ENGINEERING AND OPERATING CONSIDERATIONS INVOLVED
IN FURNISHING CIRCUITS
TO THE WESTERN UNION TELEGRAPH COMPANY UNDER SPECIAL CONTRACT

1.01 This addendum to Section 312-100-000, Issue 1 is issued to include (a) Tables 1 and 2 covering additional information on circuit levels to be employed for Facsimile and Data Signals and (b) Figure 1 covering circuit interconnection arrangements. Figure 1 of the addendum replaces Figures 1A and 1B of Section III of the "Engineering Notes" attached to the main section.

FIG. 1 - INTERCONNECTING CIRCUIT AND CIRCUIT LEVELS (DBM) FOR VFCT, FACSIMILE AND DATA LAYOUTS FURNISHED TO TELEGRAPH COMPANIES

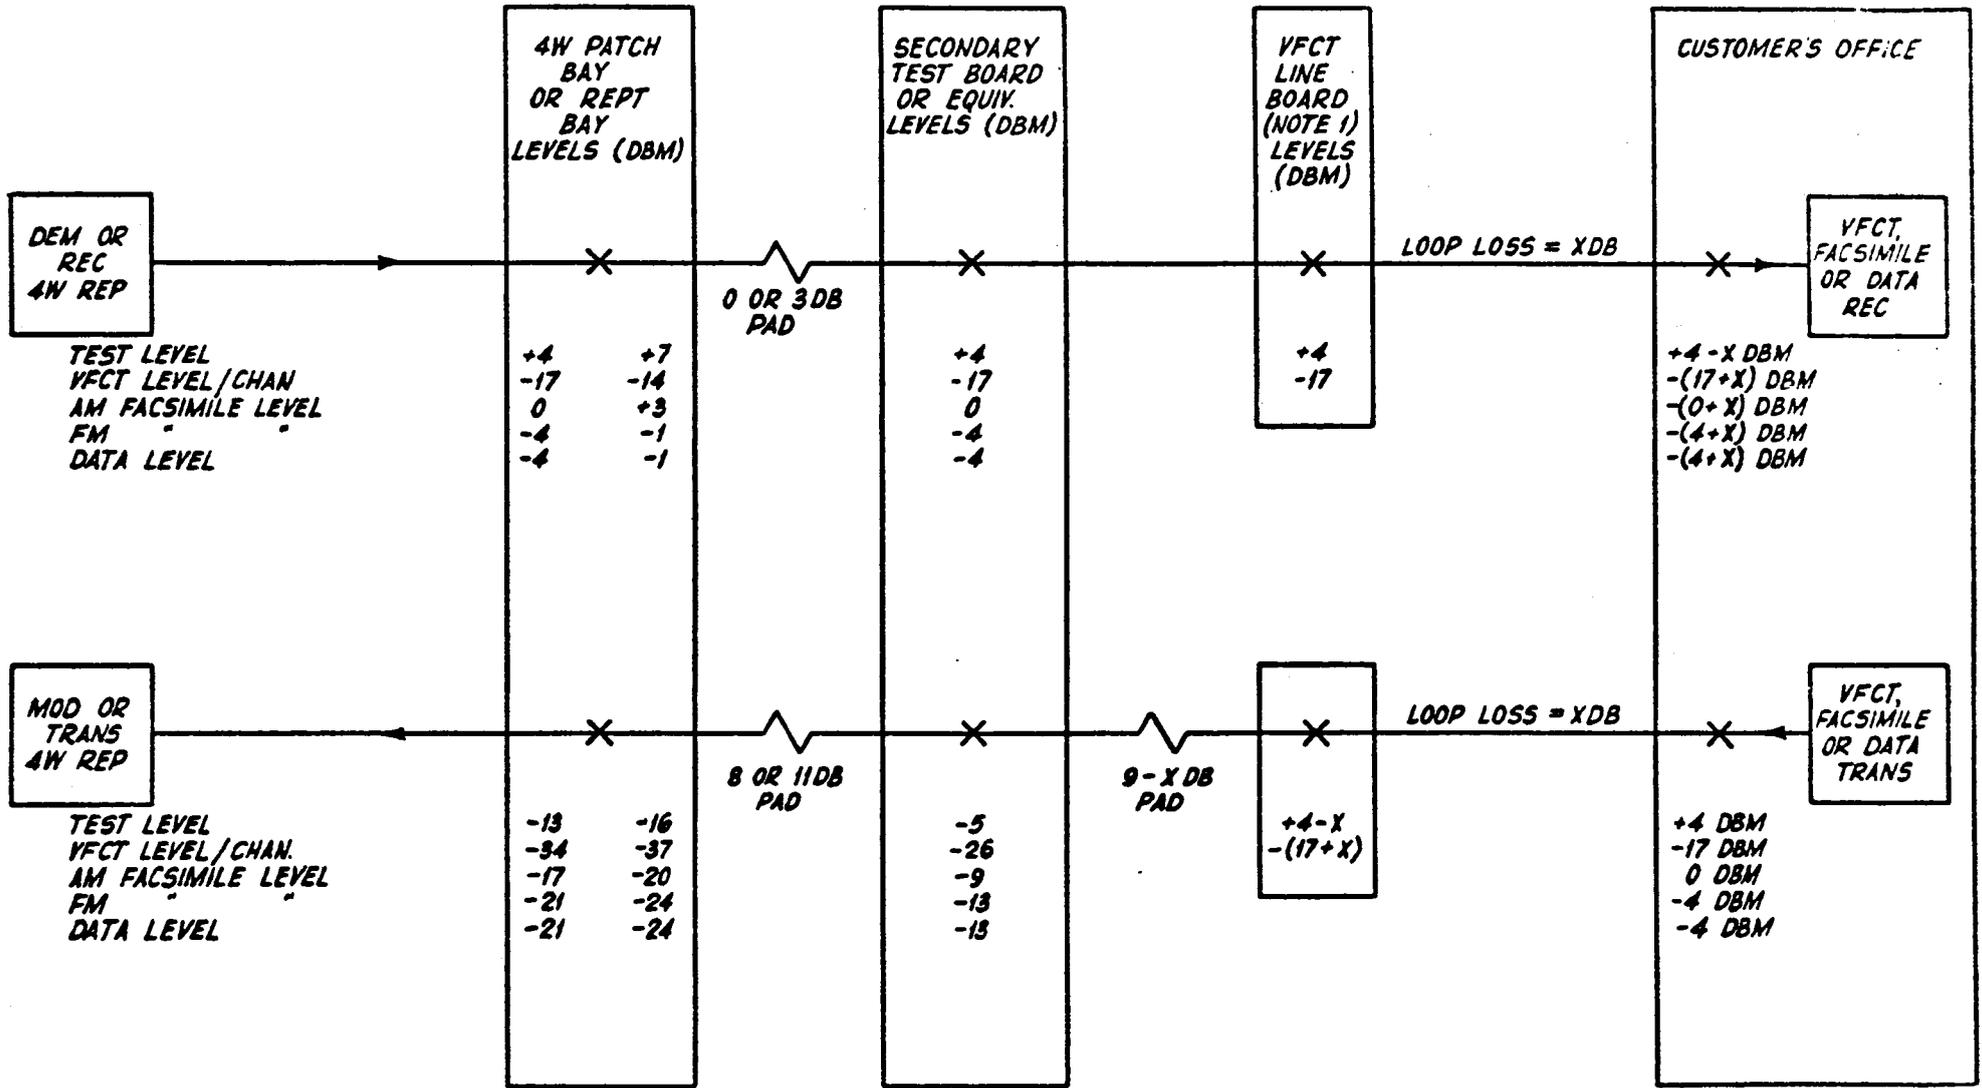
NOTE 1 - CIRCUIT ROUTED VIA VFCT LINE BOARD ONLY WHEN EXISTING DC TELEGRAPH LOOPS ARE USED.
